ADDENDUM NO. 3

**PROJECT NAME: 2016-2017 TASK ORDER CONTRACT FOR FEDERALLY FUNDED
PROJECTS PACKAGE 4 – 23-01472**

DATE: 3/10/2016

Substitute and utilize the following revised documents associated with the above named contract:

MISCELLANEOUS
CONSTRUCTION STANDARDS I

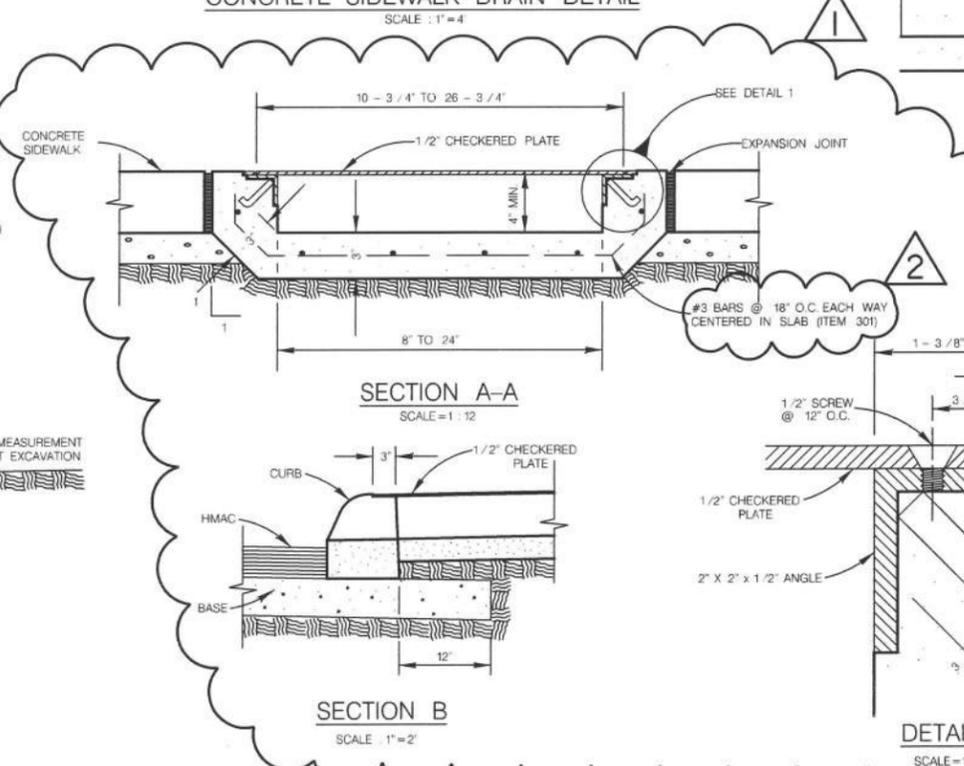
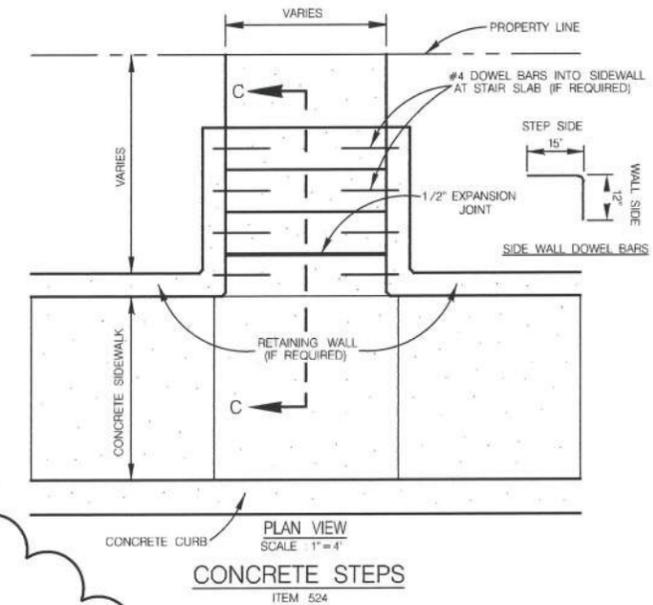
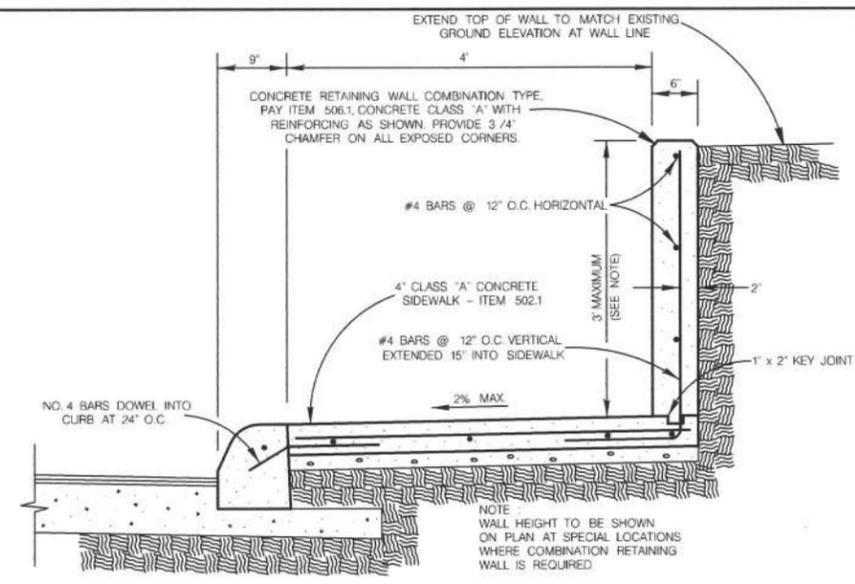
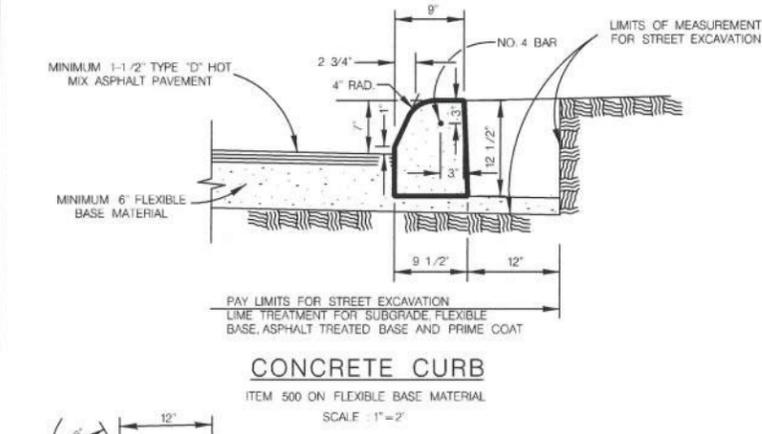
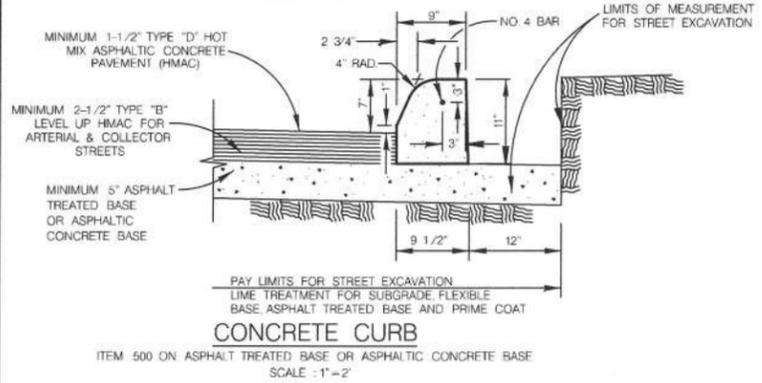
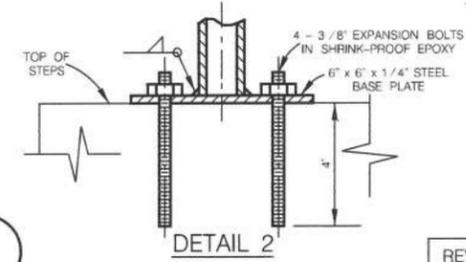
| REV. NO. | DESCRIPTION | DATE |
|----------|------------------------------------|---------|
| 2 | BASE / REINFORCEMENT MODIFICATIONS | 3/10/16 |

CONCRETE DRIVEWAY STANDARDS

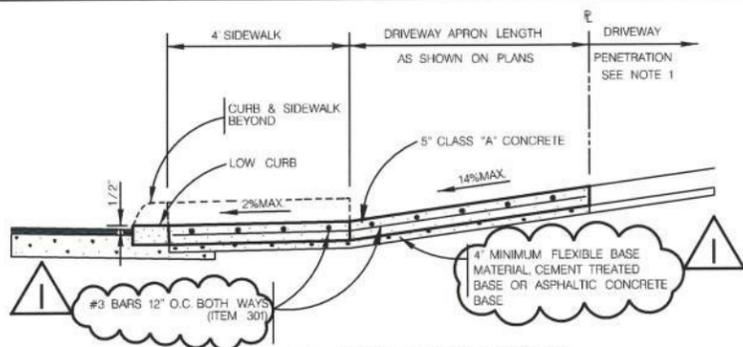
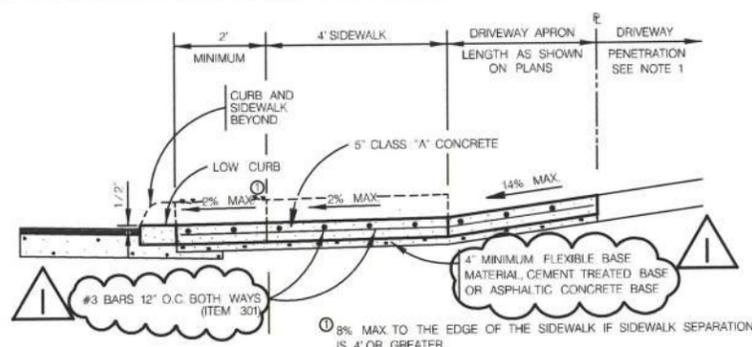
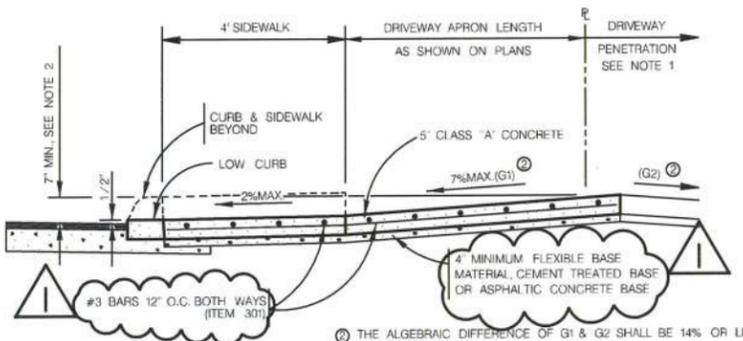
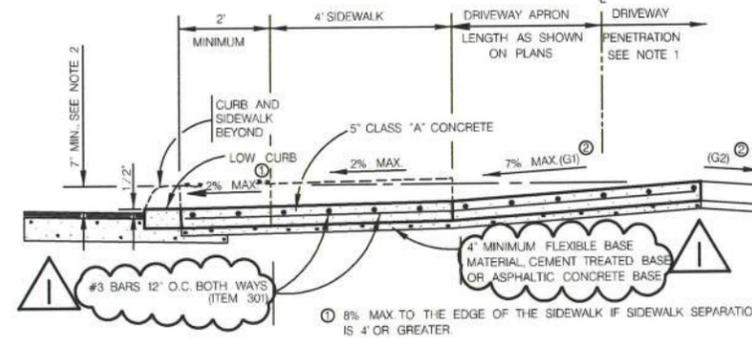
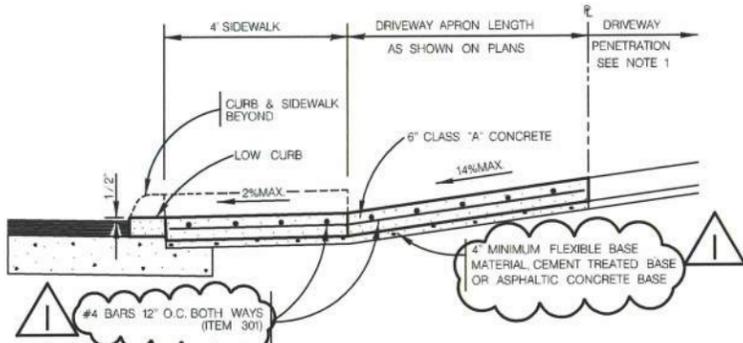
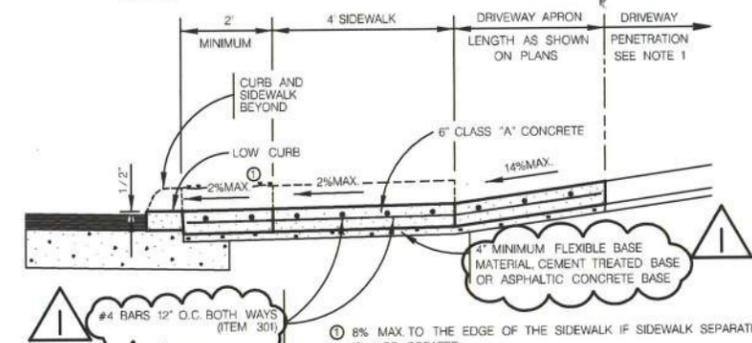
| REV. NO. | DESCRIPTION | DATE |
|----------|------------------------------------|---------|
| 1 | BASE / REINFORCEMENT MODIFICATIONS | 3/10/16 |
